**ADDENDUM No. 3**  
**REQUEST FOR TENDER ARIBA Doc4685977601**  
**CLOSING DATE: 12:00 NOON (LOCAL TIME), August 21, 2024**

**For: Request for Tenders for Interior Renovations to the 11<sup>th</sup> and 12<sup>th</sup> floor of Metro Hall,  
Located at 55 John St, Toronto**

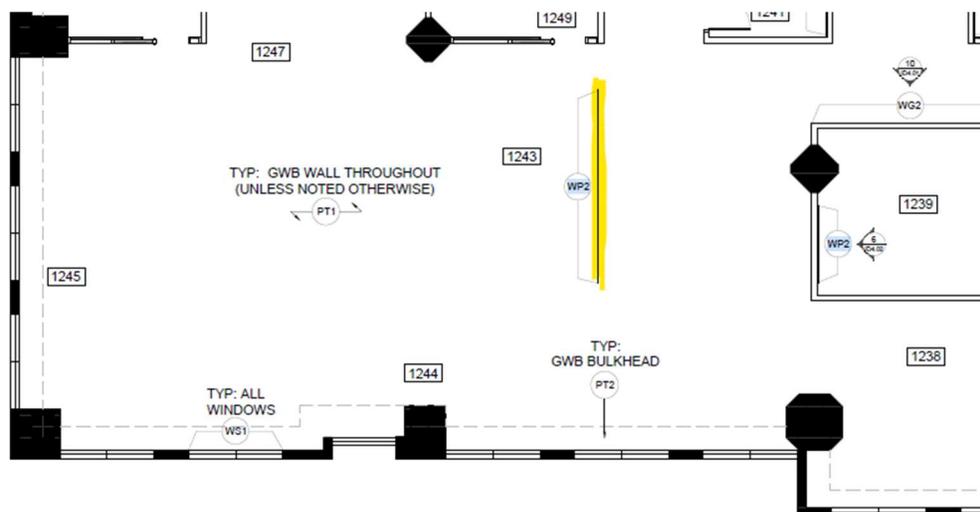
**Q4. Please confirm millwork panel shown on either end of elevator doors on the 12th floor is to be new.**

**A4.** Yes, it is new.
